**DEVIATION REQUEST
 AND DECISION FORM**

Project Name : Hillside at Lorson Ranch
 Schedule No.(s) : 5500000370, 5500000371, 5500000405, 5500000281, 5500000282, & 5500000283
 Legal Description : See Attached

HILLSIDE AT LORSON RANCH

**DEVIATION 1
 EXHIBIT**

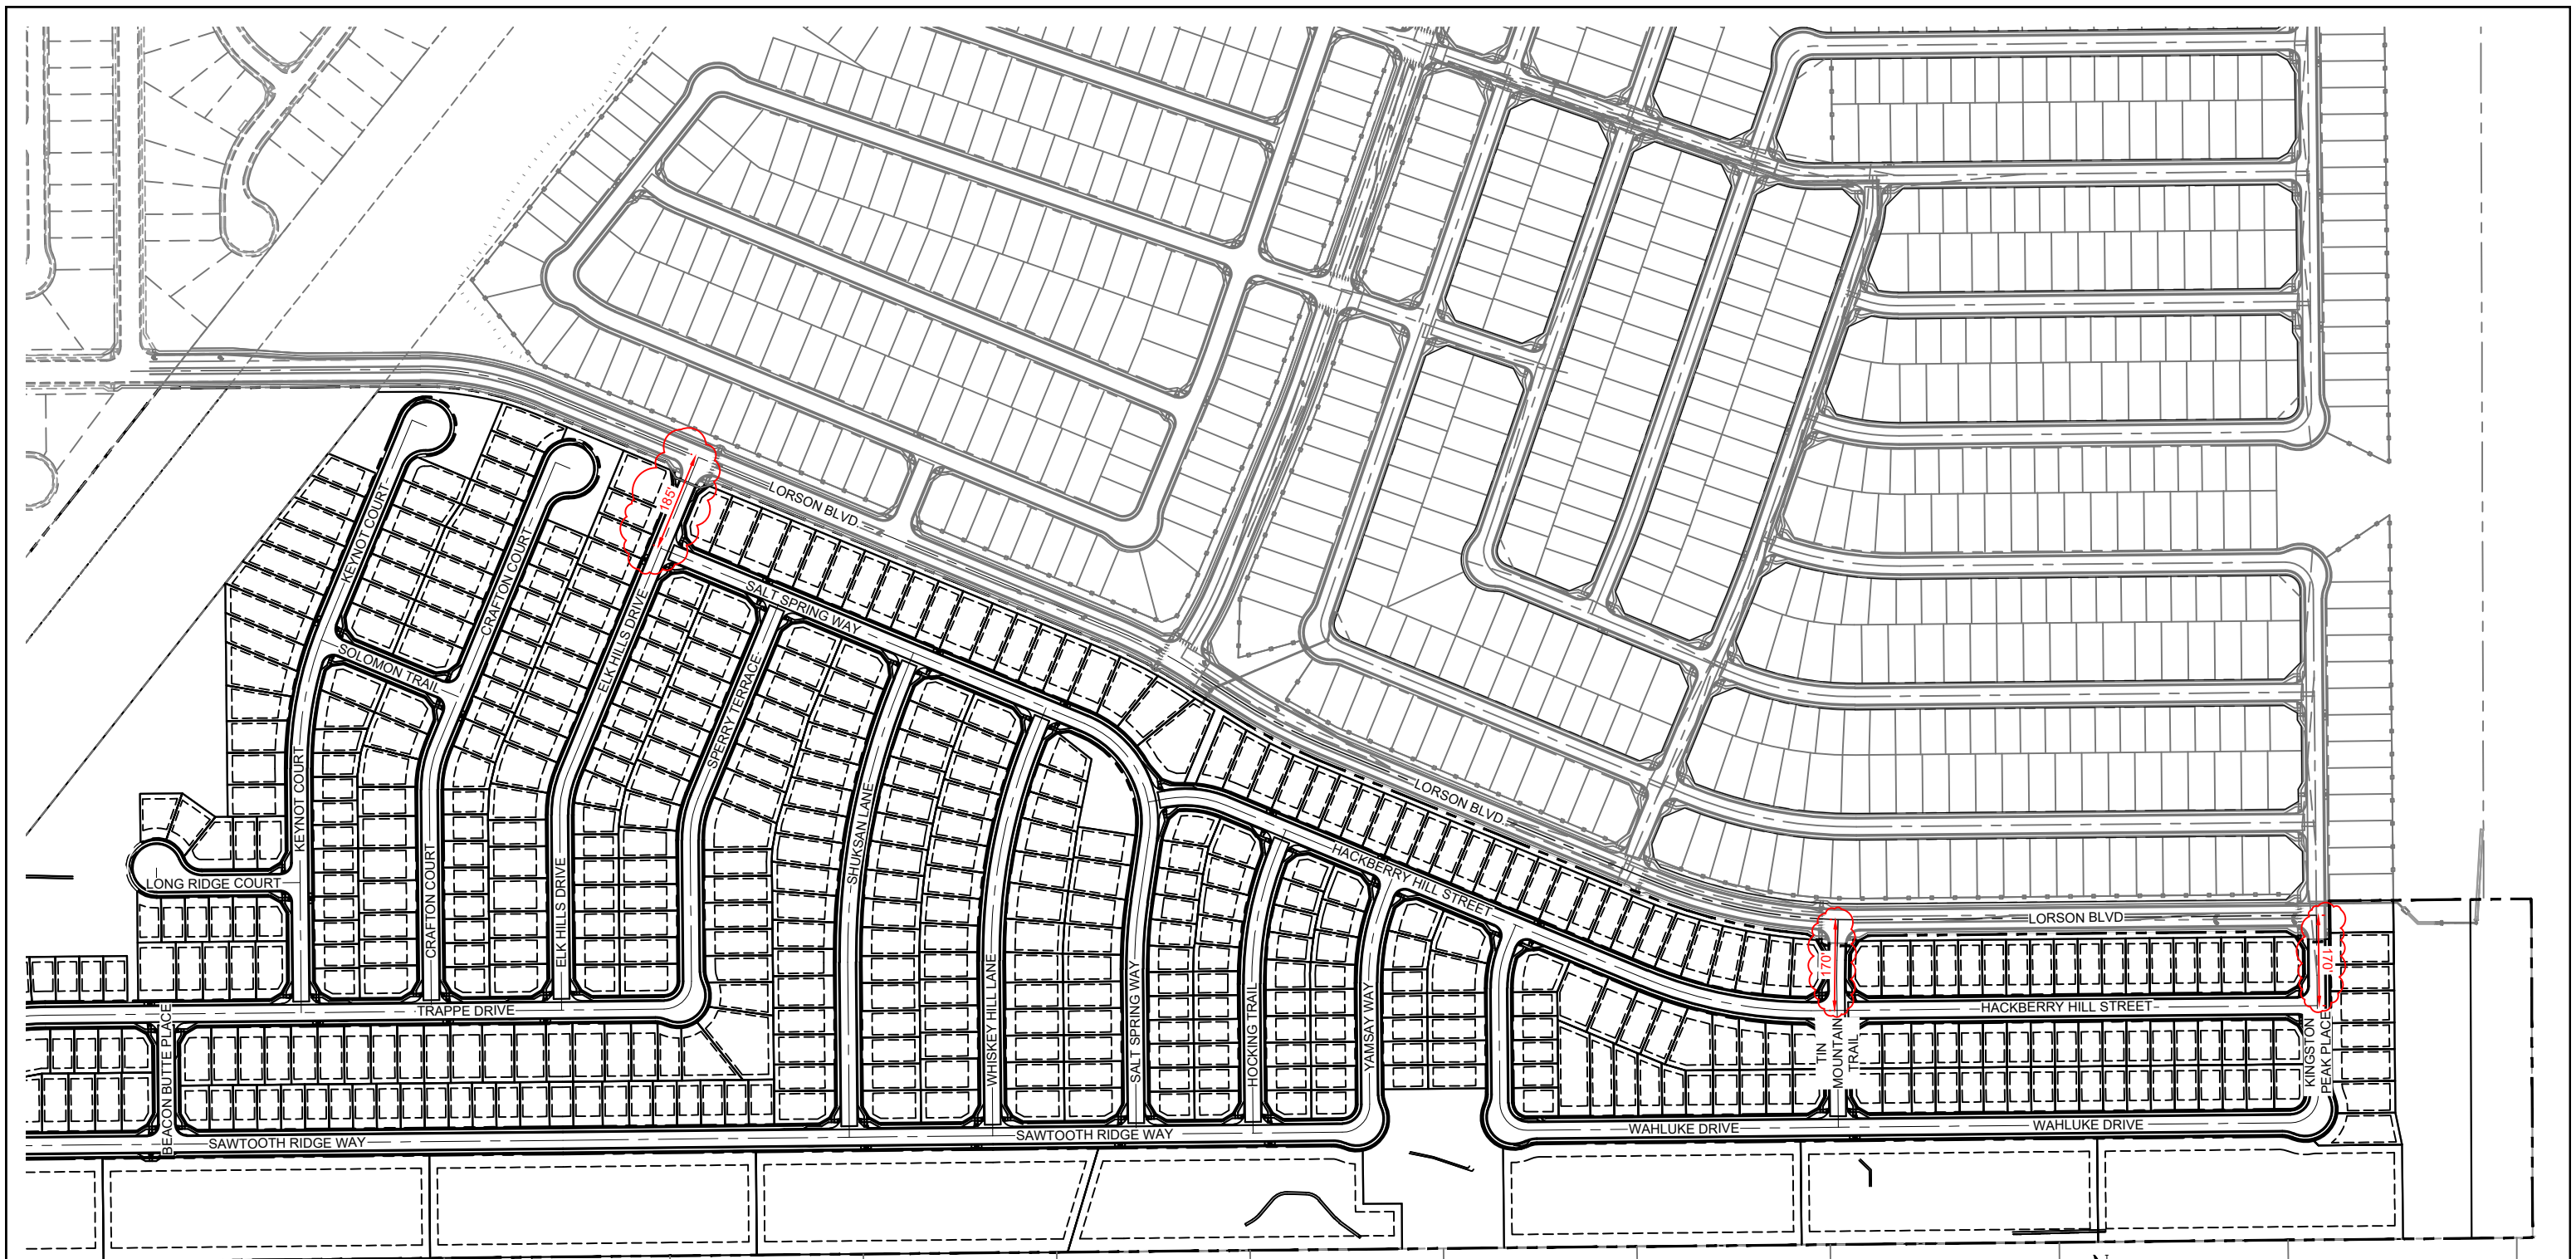
To permit urban local roadways and a collector roadway to intersect centerline to centerline closer than 200' at the intersections of Elk Hills Drive & Lorson Boulevard, Tin Mountain Trail & Lorson Boulevard, and Kingston Peak Place & Lorson Boulevard.

Lorsen Boulevard, the intersecting road, is proposed as a residential collector. Per the 200' spacing requirement, in order to meet the standard the lots would have to be 133'-135' deep in this instance. A 170'-185' intersection spacing is currently proposed at the three intersections along Lorson Boulevard.

The modification to permit roadway intersections less than 200' will not adversely affect safety or operations as these intersections are not designed as through streets, limiting traffic to residents. The intersection spacing as shown at the intersection of Kingston Place & Lorson Boulevard is 170'. The intersection spacing as shown at the intersection of Tin Mountain Trail & Lorson Boulevard is 170'. The intersection spacing as shown at the intersection of Elk Hills Drive & Lorson Boulevard is 185'. Given the limited traffic and cut through options, the shortened intersection spacing is not expected to cause any queuing constraints. In addition, pedestrian safety should not be comprised as any vehicle entering the site will have done so after a complete stop or near complete stop keeping speeds at a minimum when approach the intersection crossings.
